City of Santa Fe, New Mexico

DATE: January 14, 2025
TO: Historic Districts Review Board
FROM: Paul A. Duran, Senior Planner, Historic Preservation Division

2024-009323-HDRB, 312 Pino Rd., Downtown and Eastside Historic District, Contributing, Martinez Architecture Studio, agent for Bonny and Byron Goldstein, owners, proposes to replace windows and doors, install door grille, relocate the cellar entrance and requests exceptions to 14-5.2(D)(5)(a)(i) for primary facades of contributing structures, historic windows shall be repaired or restored wherever possible, 14-5.2(D)(1)(a) the removal of historic materials or alteration of architectural features and spaces that embody the status shall be prohibited, and 14-5.2(D)(5)(b) new material on a primary façade.

Figure 1. 312 Pino Road: Primary Façade Diagram

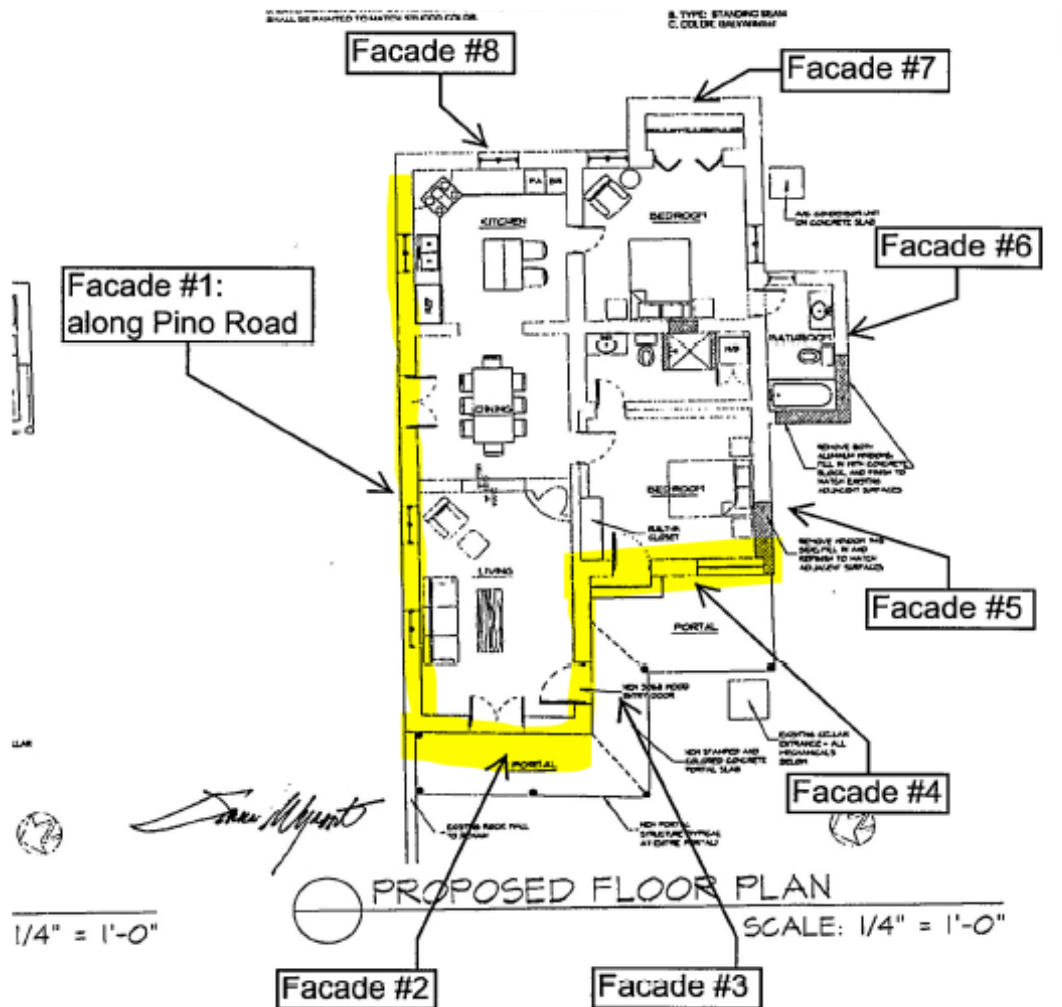
On December 8, 2015, in Case No. H-15-109A, the HDRB maintained the contributing historic status of the residential structure, designated facades 1-4 as primary including the north façade and west façades with the portals and designated the stone yard wall as a contributing structure.

- 1) Replace non-historic windows and doors (windows G, H, I 19806 and door #4 1990) on the north facade. An exception to remove historic materials is requested under section 14-5.2(D)(1)(a).

- 2) Install a security gate on the French doors on the north facade. An exception is requested to add an architectural feature to a primary facade under section 14-5.2(D)(5)(b).

- 3) Replace non-historic French doors (door #1 1990) on the west elevation in order to lower the sill to ground level.
- 4) Replace historic corner windows (window A 1960s) on the southwest corner. An exception to remove historic materials is requested under section 14-5.2(D)(5)(a)(i).
